9 July 2024

Re: Planning Reference 2023/4898/P, 2 And A Half Rudall Crescent London Camden NW3 1RS

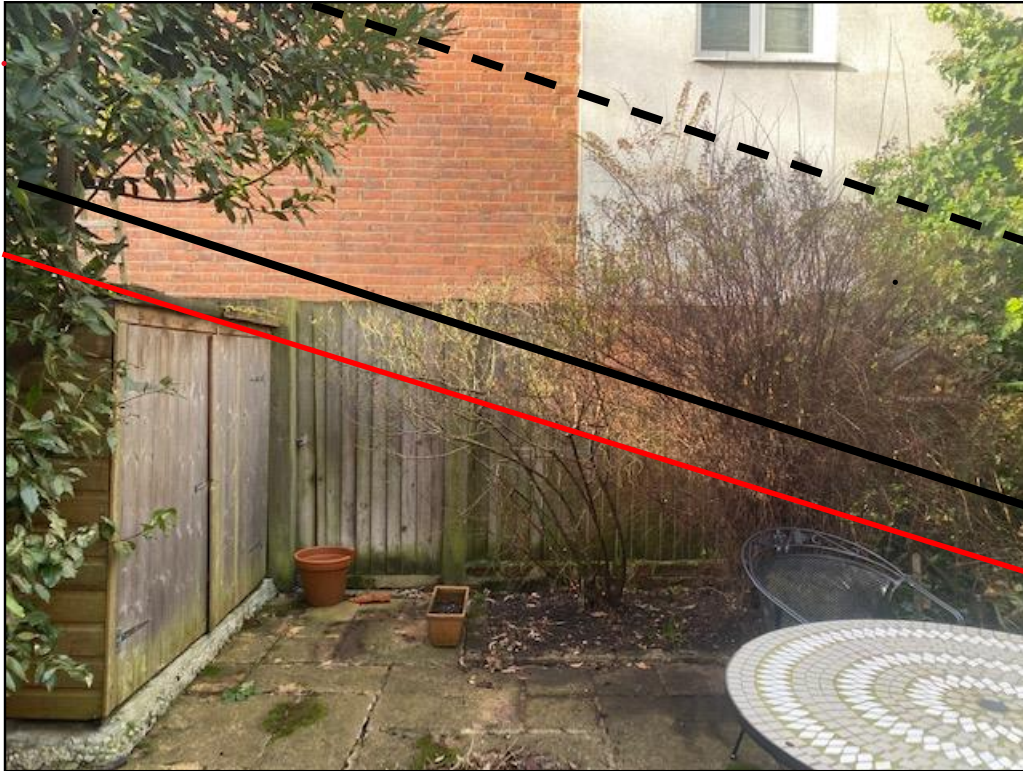
The roof of the planned extension is at least half a metre above the existing garden fence. Given the position of the extension in relation to the rear garden of 11 Willoughby Road, that would of itself significantly reduce the amenity of light to that garden. I reattach photos of the back garden of 11 Willoughby Road showing the effect of the existing fence on the level of light (red line), the significant reduction in light that would be caused by the proposed extension (hard black line) and the reduction in light from any plants that would be placed on the green roof (dashed black line).

Photo 1: The application would raise the height of the obstruction of light entering the garden of 11 Willoughby Road by between 0.5 and 3 metres. As can be seen from the angle of light currently entering the garden, this would cast the whole garden into shade. Lines added for illustration. Red line, current angle of light. Hard black line, minimum roof level of single storey extension. Broken black line, potential obstruction of light from plants on a green roof.
